# UNITED STATES PATENT AND TRADEMARK OFFICE

APPLICATION NO.	FILING DATE	FIRST NAMED INVENTOR	ATTORNEY DOCKET NO.	CONFIRMATION NO.
10/665,447	09/22/2003	Tsuyoshi Kaneko	116898	7312
25944	7590	03/10/2006	EXAMINER	
OLIFF & BERRIDGE, PLC P.O. BOX 19928 ALEXANDRIA, VA 22320			NGUYEN, PHILLIP	
			ART UNIT	PAPER NUMBER
			2828

<b>Office Action Summary</b>	<b>Application No.</b> 10/665,447	<b>Applicant(s)</b> KANEKO, TSUYOSHI	
	<b>Examiner</b> Phillip Nguyen	<b>Art Unit</b> 2828

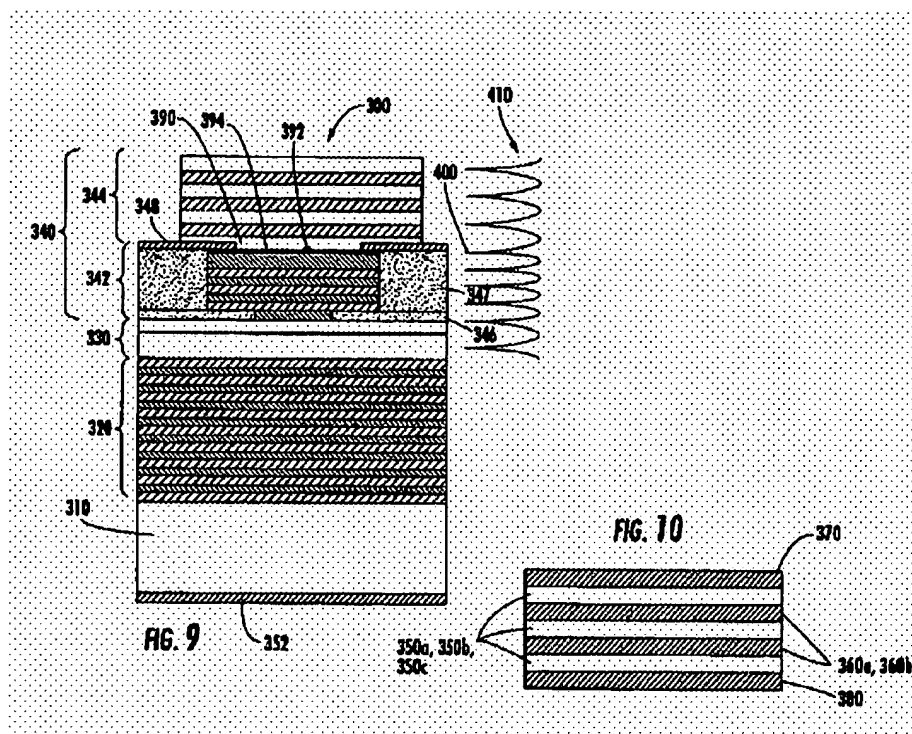
With respect to claims 1 and 6, Wasserbauer discloses in Fig. 9-10 a surface emitting semiconductor laser including a resonator formed on a substrate 318 and emitting a laser beam toward a direction vertical to the substrate from an emitting surface formed on an upper surface of the resonator, the resonator including a first mirror 320 formed above the substrate; an active layer 330; and a second mirror 342 located oppositely to the first mirror and sandwiching the active layer therebetween; a reflectivity adjustment layer 344 that is formed on the emitting surface; the second mirror including a layer of which an optical thickness is  $m_1 \lambda/2$  ( $m_1$ , a natural number), when a wavelength of the laser beam is  $\lambda$ , and an optical thickness of the reflectivity adjustment layer being  $(2m_2 - 1)\lambda/4$  ( $m_2$ , a natural number) and the optical thickness is  $\frac{1}{2}$  wavelength constituting a top layer of the second mirror (see col. 10, lines 28-30 and lines 52-56.)

With respect to claim 2, it is inherent that the reflectivity of the first region being higher than that of the second region since the first region include more layers of mirror such as layers 344.

With respect to claim 8-10, Wasserbauer discloses in the cross section of the laser; however, the plane configuration of the reflectivity adjustment layer should be a circle. Wasserbauer further discloses the reflectivity adjustment layer being arranged coaxially with a center axis of the emitting surface as shown in the same figure.

With respect to claim 22, Wasserbauer discloses the top layer of mirror 342 with the thickness of  $\frac{1}{2}$  wavelength being formed in the whole area of the second mirror 342, the reflectivity adjustment layer 344 being formed on a part of the mirror 342 because the electrode 348 is sandwiching in between.

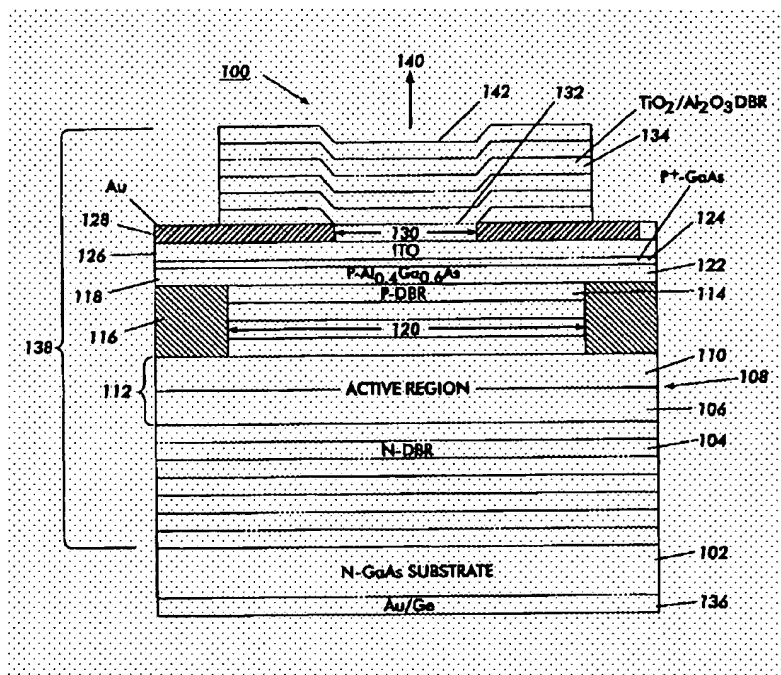
With respect to claim 3, Sun discloses in the above figure a surface emitting semiconductor laser including a resonator formed on a substrate 102 and emitting a laser beam toward a direction 140 vertical to the substrate from an emitting surface formed on an upper surface of the resonator, comprising: a first electrode 128 and second electrode 136 that inject electric current into the resonator, at least a part of the first electrode being formed on the upper surface of the resonator; and an aperture 130 that is formed on the upper surface of the resonator, the emitting surface being formed within the aperture, and a reflectivity adjustment layer 134 being formed on the emitting surface; a thickness of the reflectivity layer being uneven.

With respect to claim 4, Sun discloses the resonator including a first mirror 104 formed above the substrate, an active layer 108, and a second mirror 114 located oppositely to the first mirror and sandwiching the active layer therebetween, and reflectivity of the laser beam in the first region being larger than that of a second region, when the first region is defined as a region comprising the reflectivity adjustment layer and a lower region of the reflectivity adjustment

layer in the second mirror, and the second region is defined as a region except the first region in the second mirror. It is noted that the region that is equivalent size with reference 130 and below it is considered as the first region and the second is the area except the first region therefore it is inherent that the reflectivity of the first region has to be higher than that of the second region since the second region is blocked by the electrode 128 which produce no reflectivity.
